# Comprehensive Design Plan CDP-9306-H1

## Glassford Village, Lot 6, Block F (Key Project)

SUBJECT: Homeowner's Minor Amendment to a Comprehensive Design Plan CDP-9306-H1  
Glassford Village, Lot 6, Block F (Key Project)

# SITE PLAN

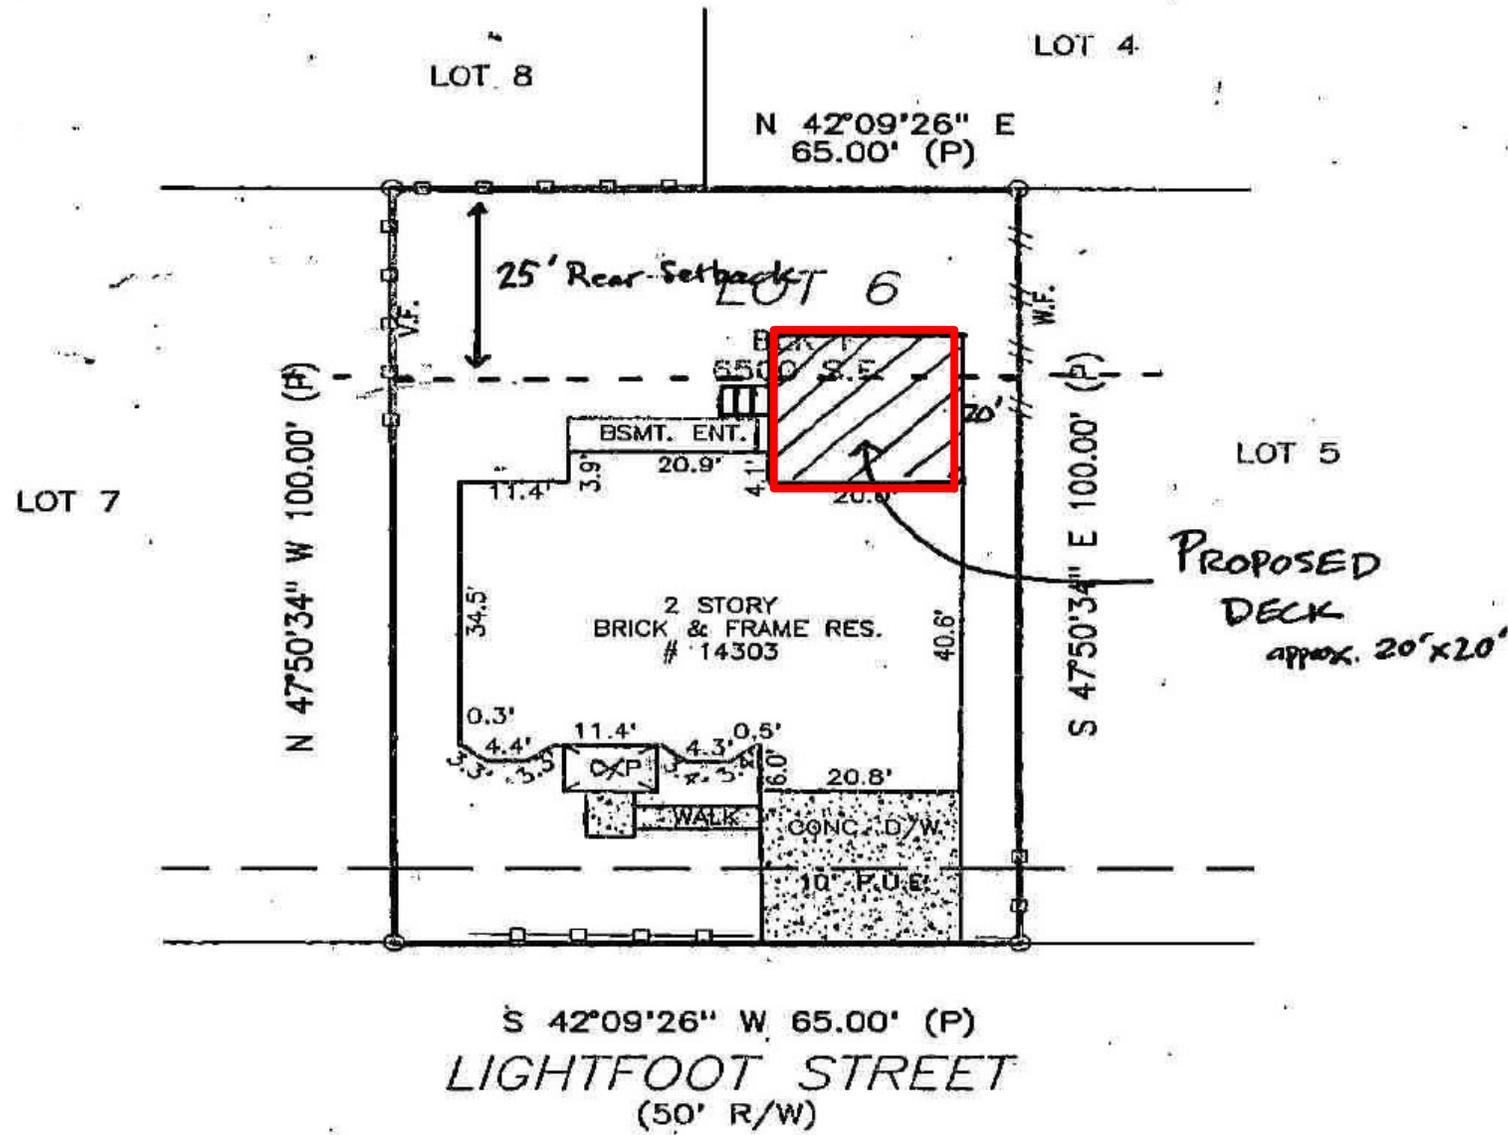
**9. Comprehensive Design Plan CDP-9306:** The project complies with the requirements of CDP-9306, except regarding the required rear yard setback. Whereas the CDP stipulates a 25-foot minimum rear yard setback, the proposed deck would sit approximately 20 feet from the rear property line. Condition 1c includes five design standards regarding the construction of decks, as follows:

The subject CDP application is being reviewed by the Planning Board, in conformance with criterion (A) above. The Planning Board is required to make a decision on the CDP application, in conformance with criterion (C) above. In regard to criterion (B), staff believes that the proposed deck will not substantially impair the intent, purpose, or integrity of the approved CDP. The modification of the rear yard setback from 25 feet to 20 feet for the proposed deck will not be detrimental to the community. The proposed deck will not negatively impact the visual characteristics of the neighborhood because it will be located to the rear of an existing single-family dwelling and not visible from the street or public space.

1. Prior to certification, note on the plan that if the deck is built 4 feet or less in height above ground level, the undercroft (open underside of the deck) shall be screened from view by decorative lattice or other screening of similar durability and visual interest.

MD1406.2262  
LOCATION DRAWING  
LOT 6, BLOCK F  
GREENS PISCATAWAY,  
PRINCE GEORGE'S COUNTY, MARYLAND  
06-20-2014 SCALE 1"=30'

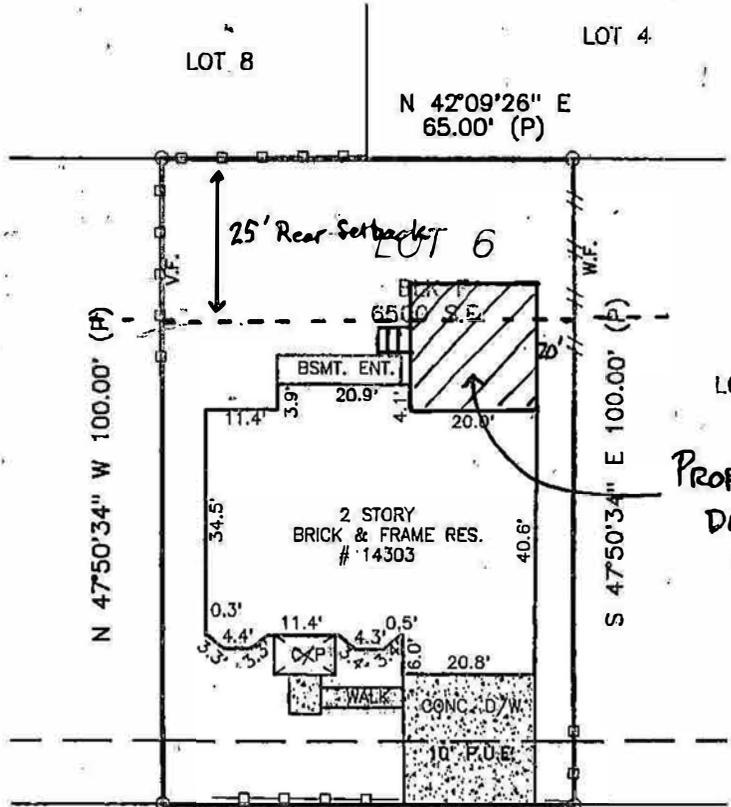
PROPOSED  
DECK  
APPROX. 20'x20'
